Advisory Action

07/411,576

Maglica

FIG. 1.

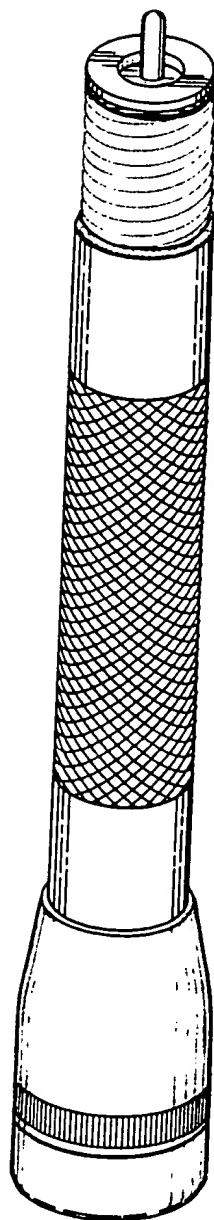
The shape of the flashlight head has not been amended for consistency with the parent application. The benefit of the filing date of parent case 06/648032 is denied. Also, the threaded portion still appears proportionally wider in the

FIG. 2.

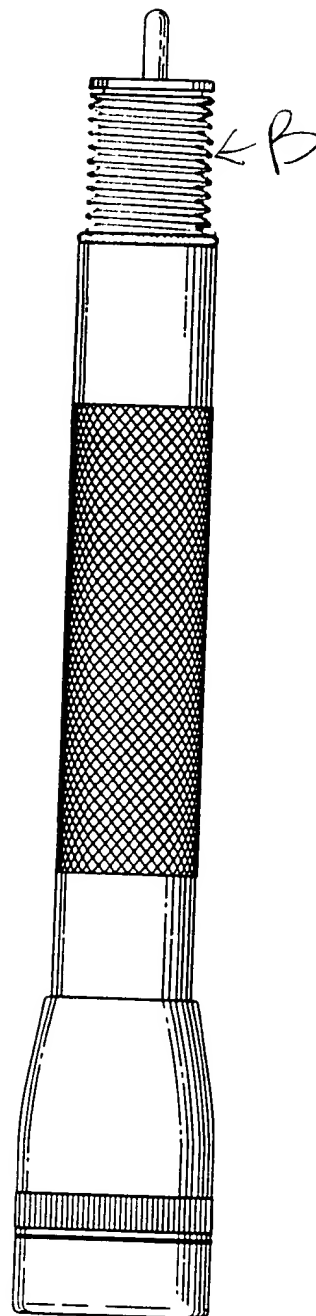
1. The drawing submitted 02/27/96 is objected to for the following reasons:
 - a) Upon further consideration of the drawings, the end shown in Fig.3 shows one less concentric circle than the original Fig.3. Also, the middle concentric circles are spaced closer together than in the original Fig.3. Note A on the attached photocopy.
 - b) The threaded portion in Fig.2 is drawn in the opposite direction from Fig.1. Consistency is required. Note B.
 - c) The Fig.4 end view shows one less concentric circle than in the original Fig.4. Note C.

Correction is required. 35 U.S.C. § 112 paragraph 1, 37 C.F.R. § 1.152.
